SCHEDULE OF AMENDMENTS:

PROJECT
 28 Lockwood avenue,
 BELROSE
 NSW 2085

STATUS ISSUE FOR SECTION 4.55 **JOB NO.**

DRAWING
 Roof plan

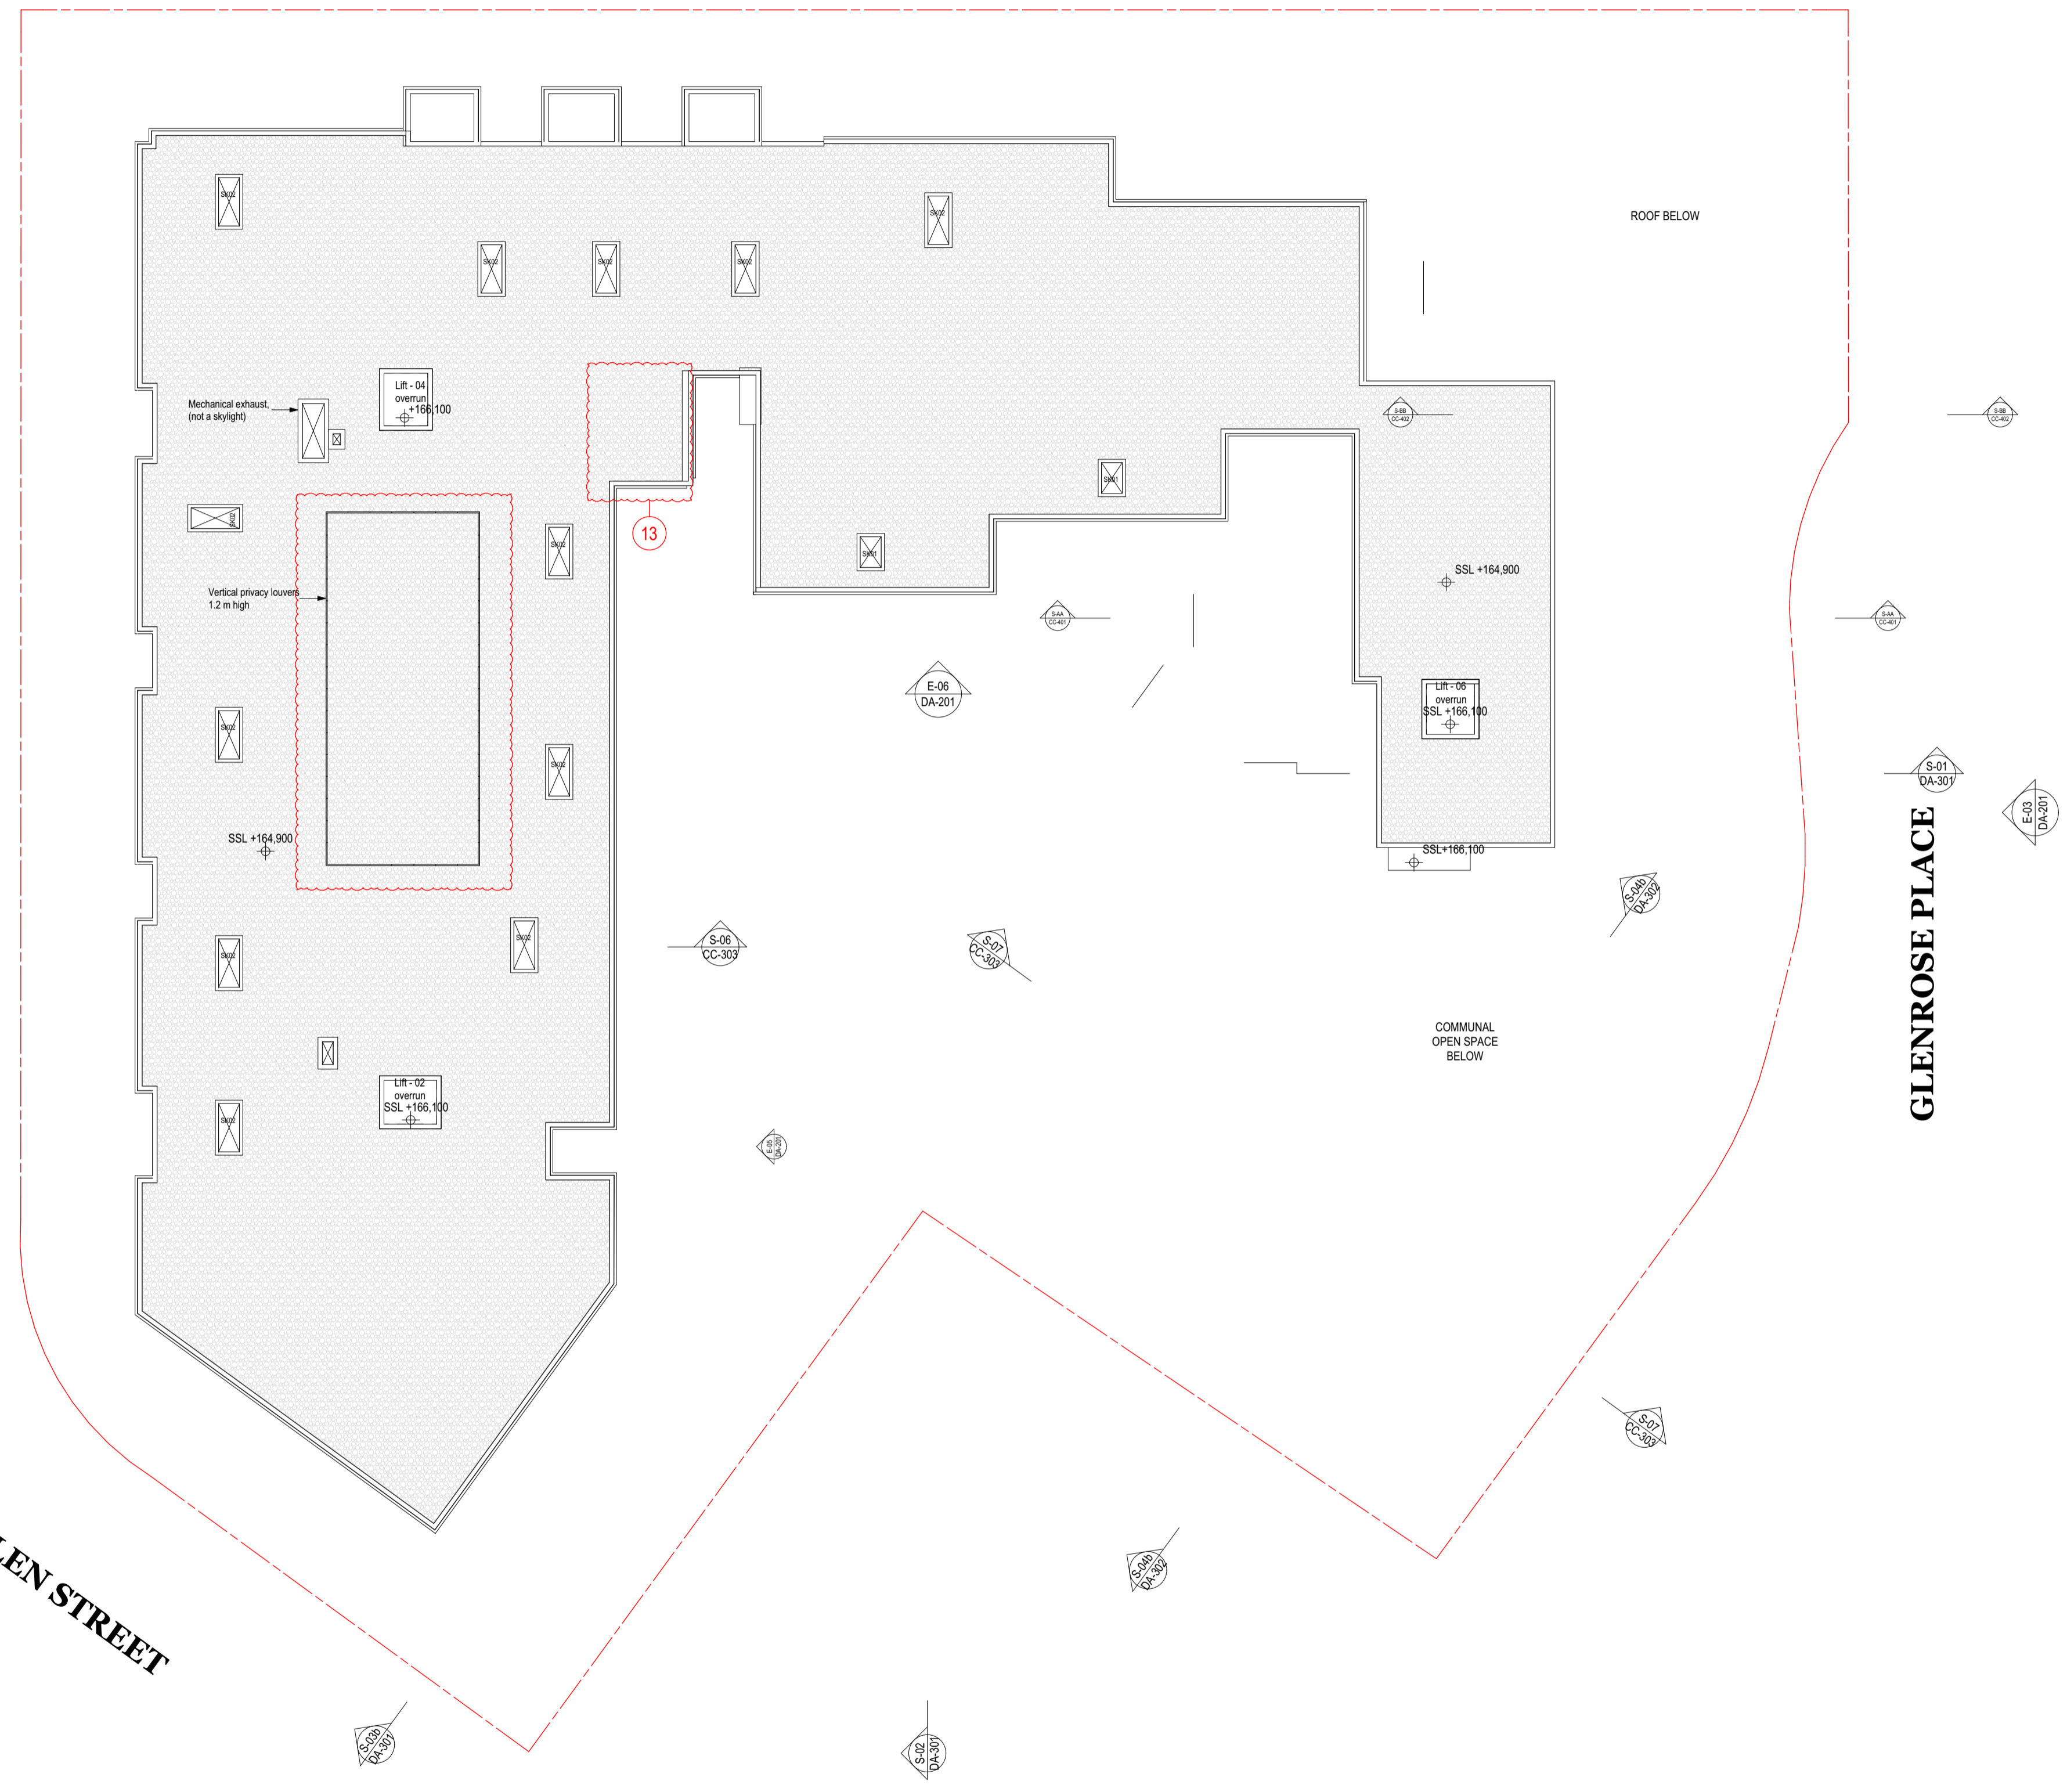
- 1- A second electrical substation is proposed due to the electrical requirements of the building as requested by the electrical engineer.
- 2- EF-04, EF-05 & EF-06: the "painted concrete" is replaced with "render paint" as specified in the legend of the schedule of finishes.

- 3- Retail 05 - on ground floor level: The external wide entry ramp to retail 05 has been enclosed to be an internal space within the shop with a narrower internal ramp.

- 4- The void space which is adjacent to retail 03 on ground floor level has been removed and that space has been allocated to retail 03.
- 5- Highlight windows W66, W67 and W68 have been added to retail 03 and retail 05 on lower ground floor to bring natural light into the retail.

- 6- Unit LG12: The internal storage has been re-located to either sides of the TV unit, replaced with a powder room with minor adjustments to the layout of the unit.

- 7- Unit LG13: The internal storage has been re-located to one side of the TV unit and replaced with a powder room.
- 8- Unit LG04: A third bedroom and a balcony has been added to this unit and the surface area of this unit has increase by 20.58 m2. The entry to this unit has been shifted away from lift 05 overrun, since the lift overrun extrudes 600 mm over the SSL of lower ground floor. This change is crucial for lift 05 to work.

- 9- Unit LG01: The external wall of the living room has been pushed out 500 mm to improve the internal layout of the unit.
- 10- Unit 1.12: The external north facing wall has been pushed out 2300 mm to improve the internal layout of the unit and its area has increased by 18.6 m2.

- 11- Unit G04: A third bedroom and a balcony has been added to this unit and the surface area of this unit has increase by 20.73 m2.
- 12- Unit L1.04: The surface area of this unit has increase by 18.63 m2. The internal layout has been amended and an additional balcony is proposed.

- 13- The roof is extended over the new extension of unit L1.04.
- 14- Unit L1.11: internal amendments to floor plan to avoid drainage of bathrooms inside lift 01 overrun below.

DRAWING		ELEVATIONS	
DATE	JAN 2024	NORTH	
DRAWN	JS	CHECK	NL
SCALE	1:200, 1:160, 3:0	@A1 Sheet Size	
DWG NO.	DA-201	ISSUE	3
STATUS	ISSUE FOR SECTION 4.55	JOB NO.

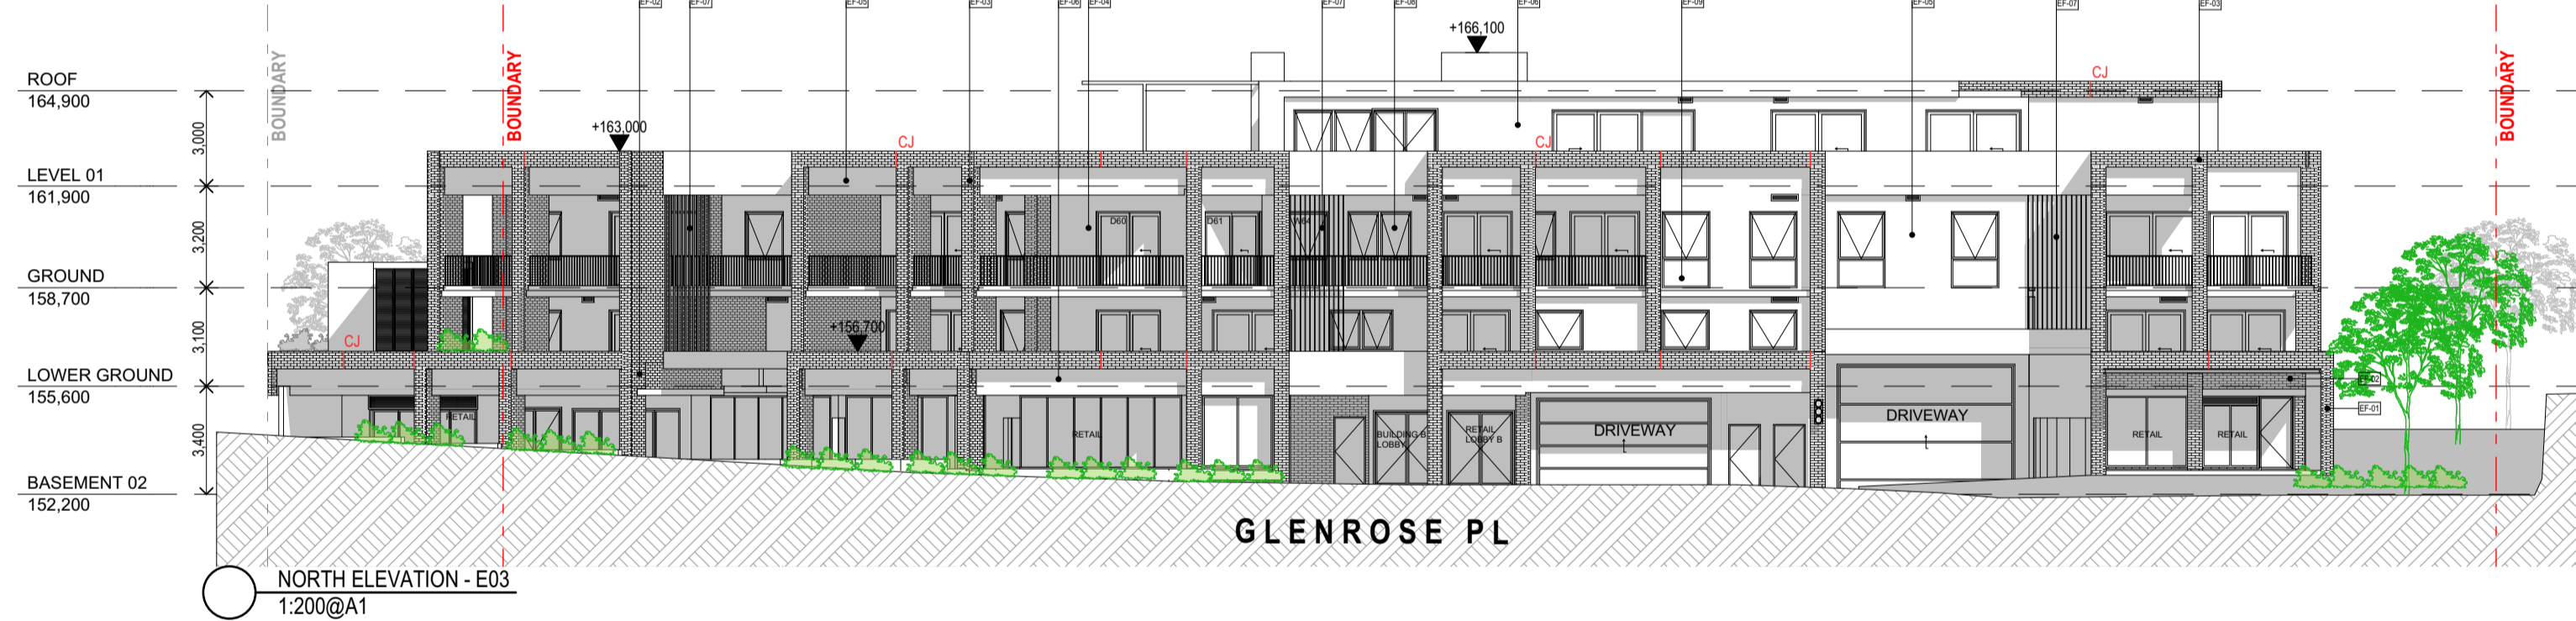
- 1- A second electrical substation is proposed due to the electrical requirements of the building as requested by the electrical engineer.
- 2- EF-04, EF-05 & EF-06: the "painted concrete" is replaced with "render paint" as specified in the legend of the schedule of finishes.

- 3- Retail 05 - on ground floor level: The external wide entry ramp to retail 05 has been enclosed to be an internal space within the shop with a narrower internal ramp.

- 4- The void space which is adjacent to retail 03 on ground floor level has been removed and that space has been allocated to retail 03.
- 5- Highlight windows W66, W67 and W68 have been added to retail 03 and retail 05 on lower ground floor to bring natural light into the retail.

DRAWING
 SECTIONS

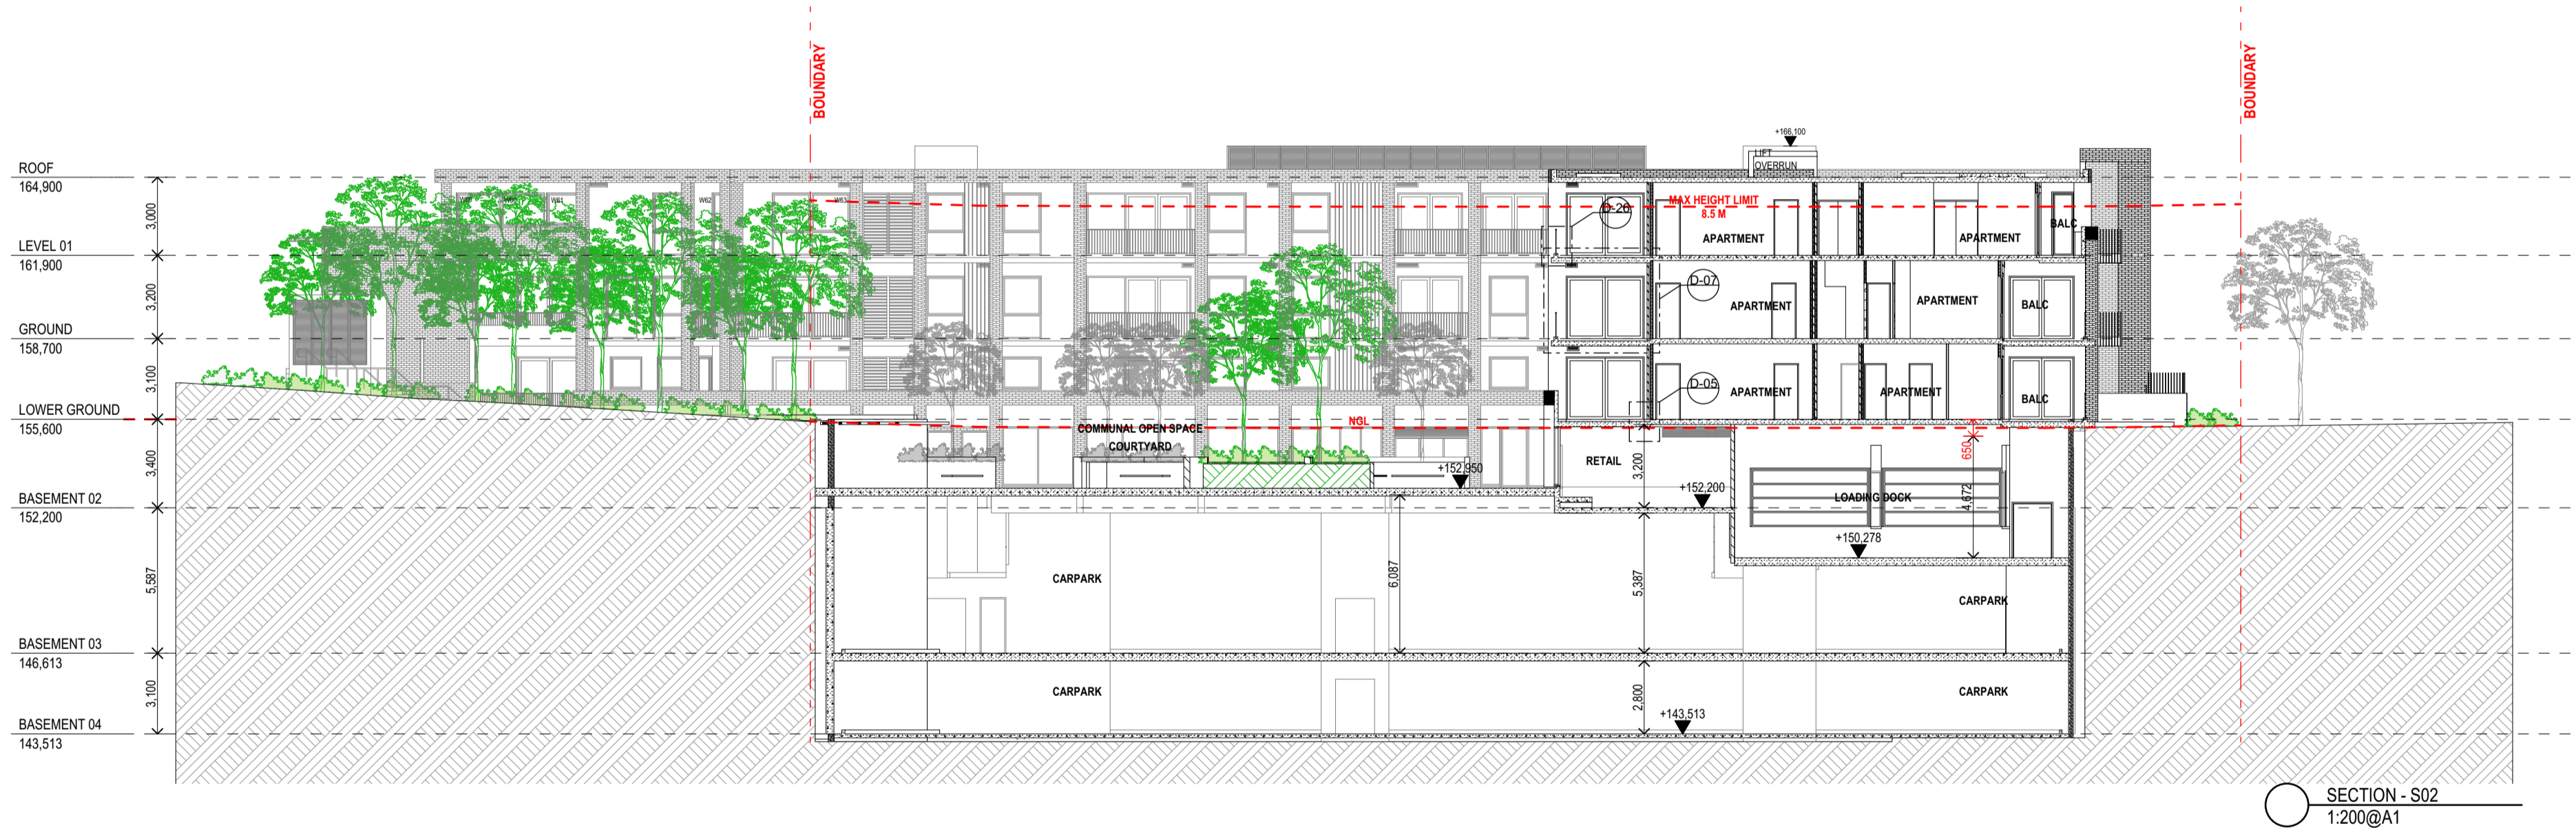
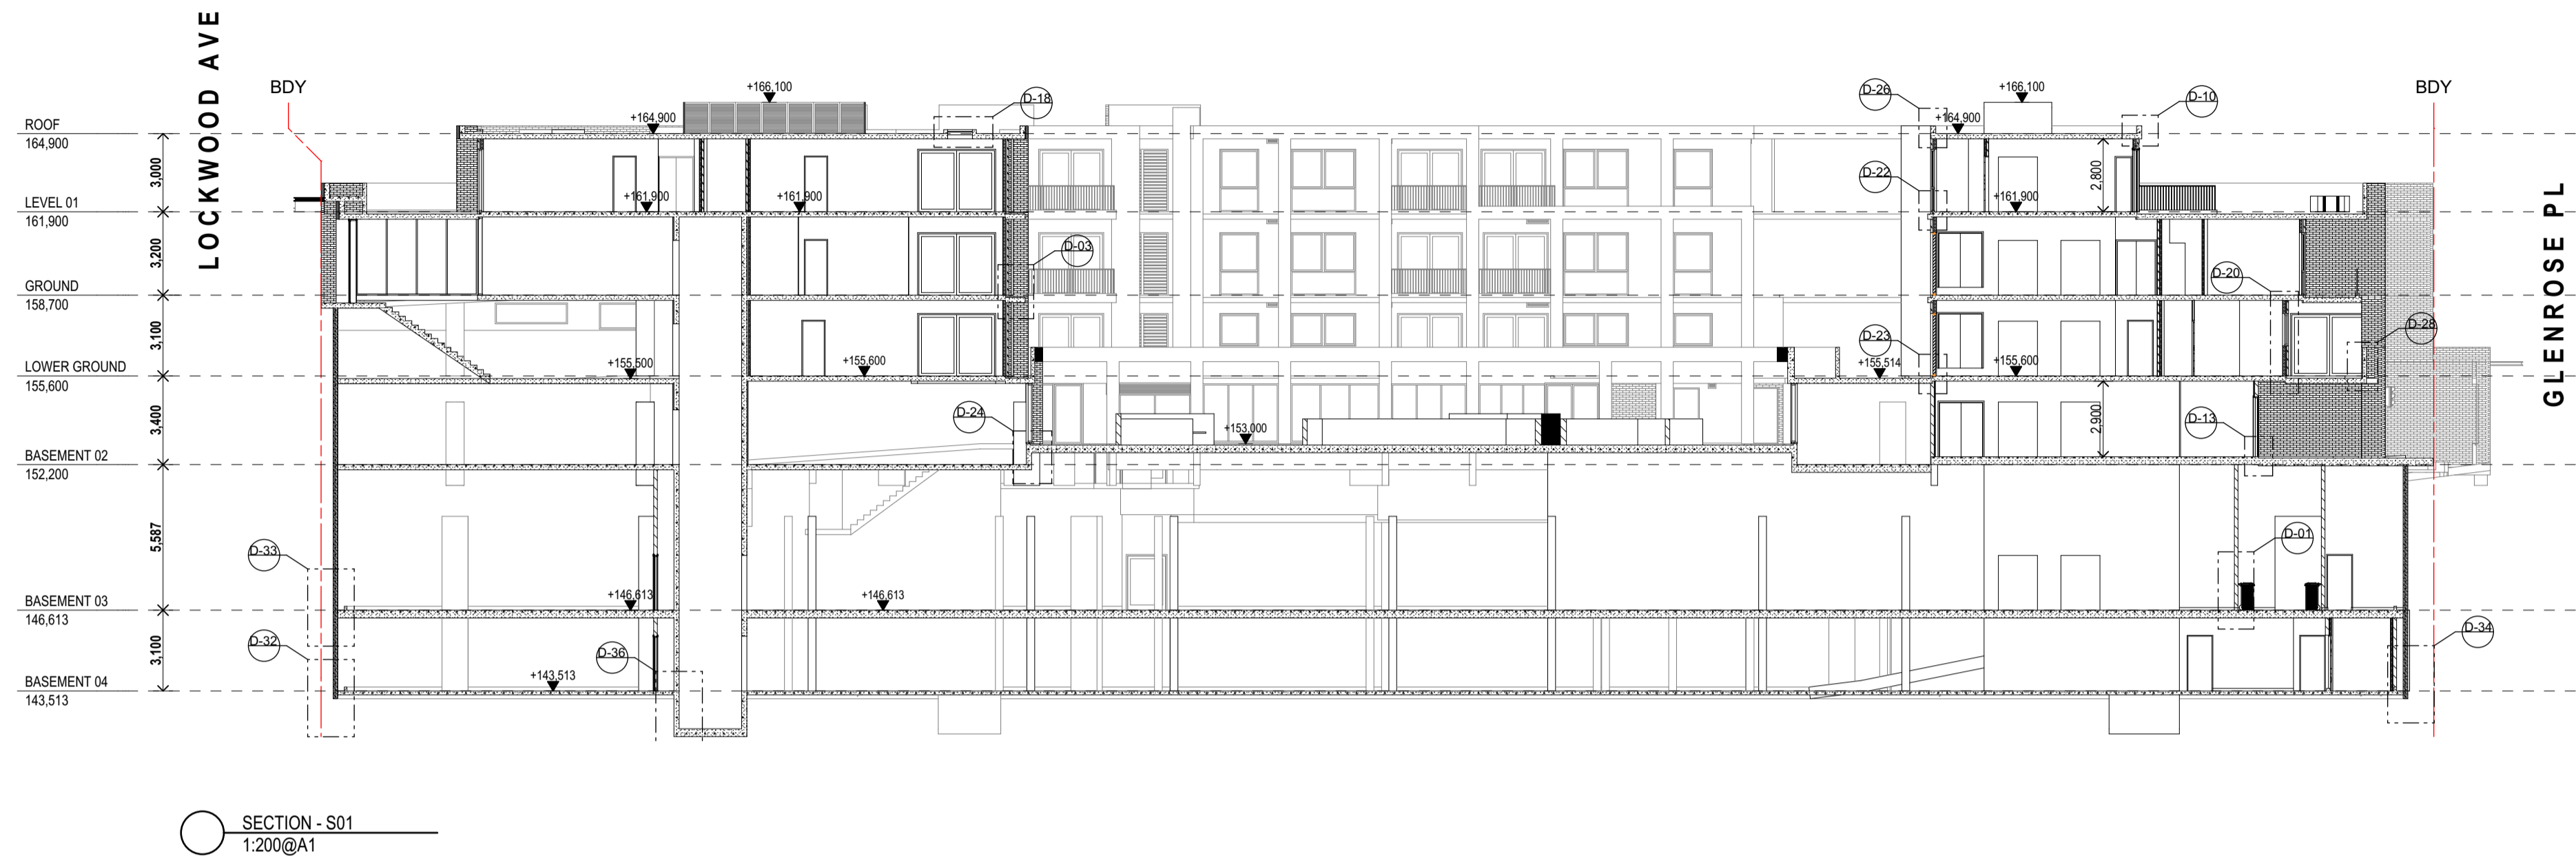
- 1- A second electrical substation is proposed due to the electrical requirements of the building as requested by the electrical engineer.
- 2- EF-04, EF-05 & EF-06: the "painted concrete" is replaced with "render paint" as specified in the legend of the schedule of finishes.

- 3- Retail 05 - on ground floor level: The external wide entry ramp to retail 05 has been enclosed to be an internal space within the shop with a narrower internal ramp.

- 4- The void space which is adjacent to retail 03 on ground floor level has been removed and that space has been allocated to retail 03.
- 5- Highlight windows W66, W67 and W68 have been added to retail 03 and retail 05 on lower ground floor to bring natural light into the retail.

- 7- Unit LG13: The internal storage has been re-located to one side of the TV unit and replaced with a powder room.
- 8- Unit LG04: A third bedroom and a balcony has been added to this unit and the surface area of this unit has increase by 20.58 m2. The entry to this unit has been shifted away from lift 05 overrun, since the lift overrun extrudes 600 mm over the SSL of lower ground floor. This change is crucial for lift 05 to work.

- 11- Unit G04: A third bedroom and a balcony has been added to this unit and the surface area of this unit has increase by 20.73 m2.
- 12- Unit L1.04: The surface area of this unit has increase by 18.63 m2. The internal layout is proposed.

- 13- The roof is extended over the new extension of unit L1.04.
- 14- Unit L1.11: internal amendments to floor plan to avoid drainage of bathrooms inside lift 01 overrun below.
